SERVICE BULLETIN

Classification: FA12-003a	Reference: NTB12-090a	Date: November 26, 2013
------------------------------	--------------------------	----------------------------

2013 ALTIMA; DRUMMING NOISE IN FRONT SUSPENSION WHEN TURNING

This bulletin has been amended. The Parts Information section has been revised. No other changes have been made. Please delete all previous versions.

Figure 1 and Figure 2 show witness mark from coil spring. Shown with right front Strut removed for reference only.

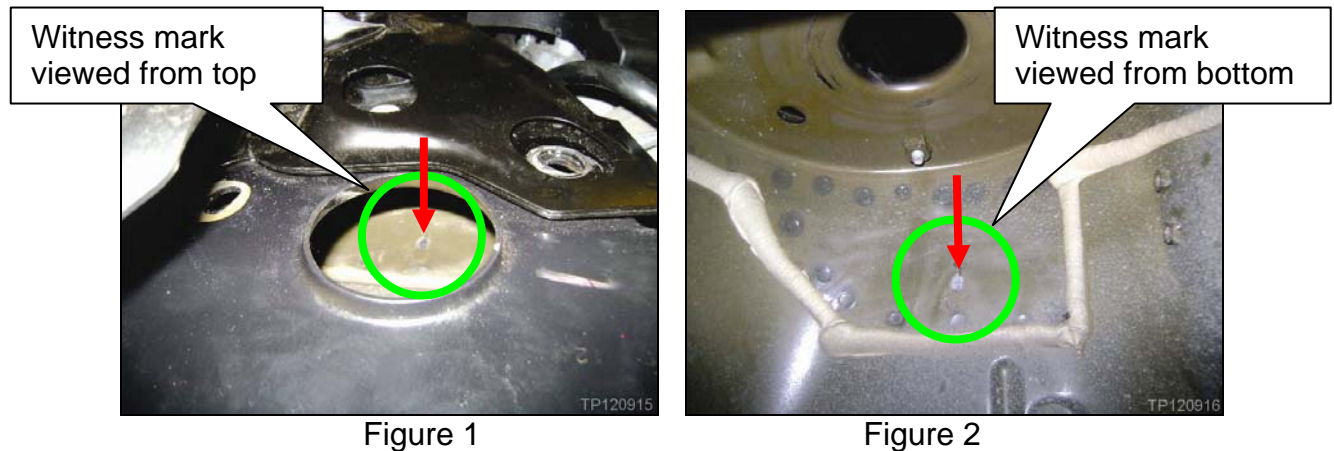
- A witness mark is present as shown in Figures 1 and 2 on page 3.

1. Remove right side strut assembly from vehicle.
2. Replace strut coil spring with model specific part listed in **PARTS INFORMATION**, above.
3. While strut is out of vehicle, clean witness mark of any rust, corrosion, etc. See Figure 1 and Figure 2 on the next page.

4. Apply Zinc-Rich Primer (see **PARTS INFORMATION**) within 12 mm (approx. ½ inch) on and around the witness mark area; allow to dry.
5. Apply Bitumen Wax (see **PARTS INFORMATION**) within 12 mm (approx. ½ inch) on and around the witness mark area; allow to dry.
 - Follow instructions on the label of Bitumen Wax.
6. Reinstall strut into vehicle.
